Our ref: RA/2024/147506/02-L01
Your ref: 2024/92283

**REDEVELOPMENT OF MARKET WITH ADDITION OF MEZZANINE FLOOR –
DEWSBURY MARKET, 32 CLOTH HALL STREET, DEWSBURY, WF13 1QE**

Thank you for re-consulting us on this application following submission of a revised FRA by BDP Civil and Structural Engineering Group, referenced P3001350 Revision P03 and dated 25 November 2024, which we received on 25 November 2024.

Figure 1 - pre-development

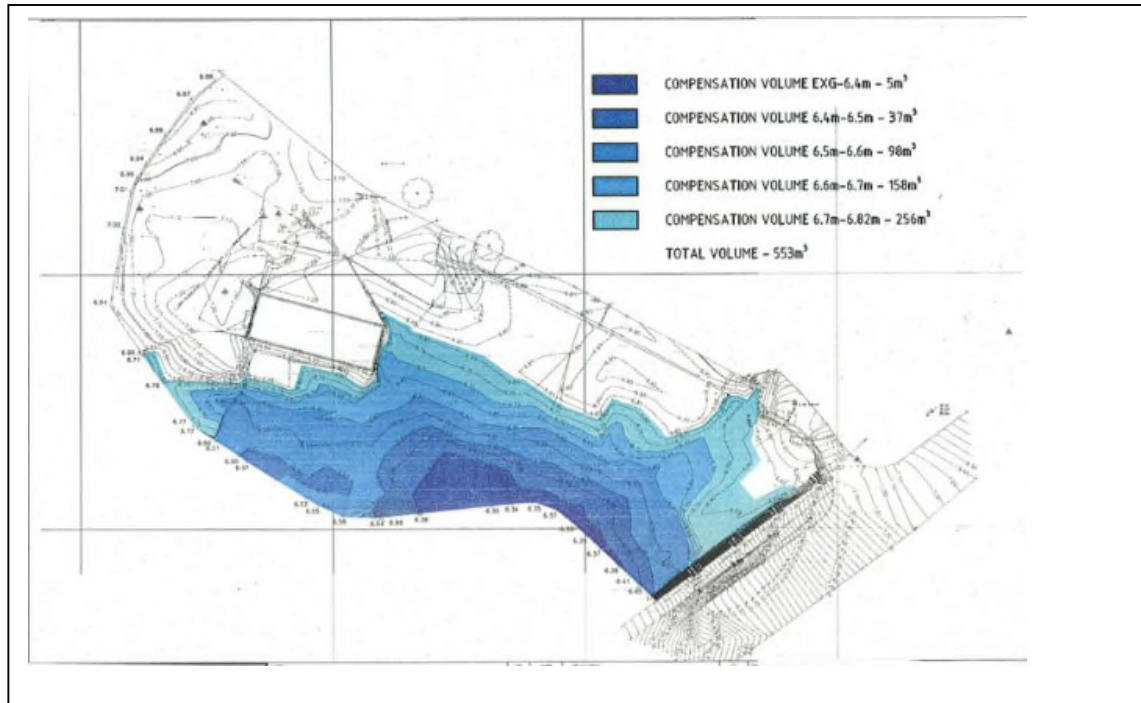
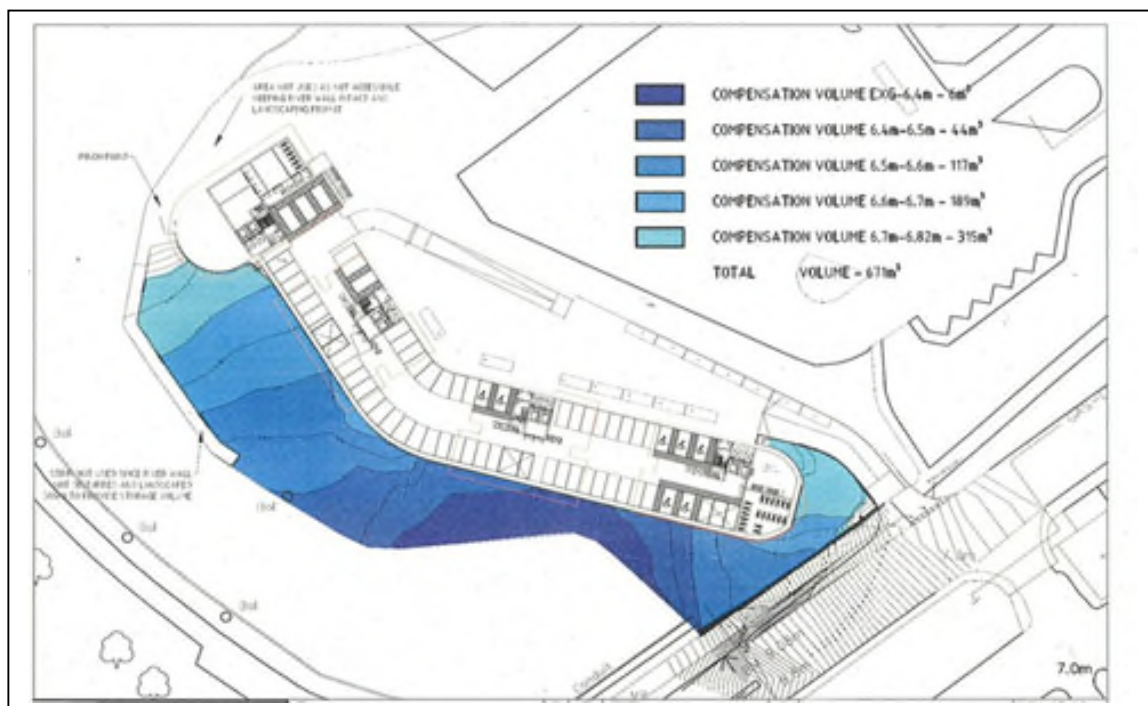
The FRA bases its compensatory storage assessment and calculations on flood zone 3a. Flood zone 3a does not consider climate change. Instead, you should use the 1% AEP plus climate change event to inform your assessment.

Additionally, it is not clear how you arrived at 22m³ increase. Furthermore, it is not clear looking at the Surface Level Data key exactly where volume is reduced and gained at different intervals of the events in metres Above Ordnance Datum (mAOD).

To overcome this, you should use contour plans of the existing and proposed topographical differences. This will enable you to display exactly where volume is reduced and gained through horizontal slices taken at vertical intervals of a flood event level (mAOD). Please present details showing where volume is reduced or gained at vertical intervals of a flood event in mAOD, as demonstrated in the examples in Figure 1 (Pre-development) & Figure 2 (Post-development) below:

Please note the example above uses 0.1 m vertical intervals. However, you may wish to use 0.2 m vertical intervals depending on the range.
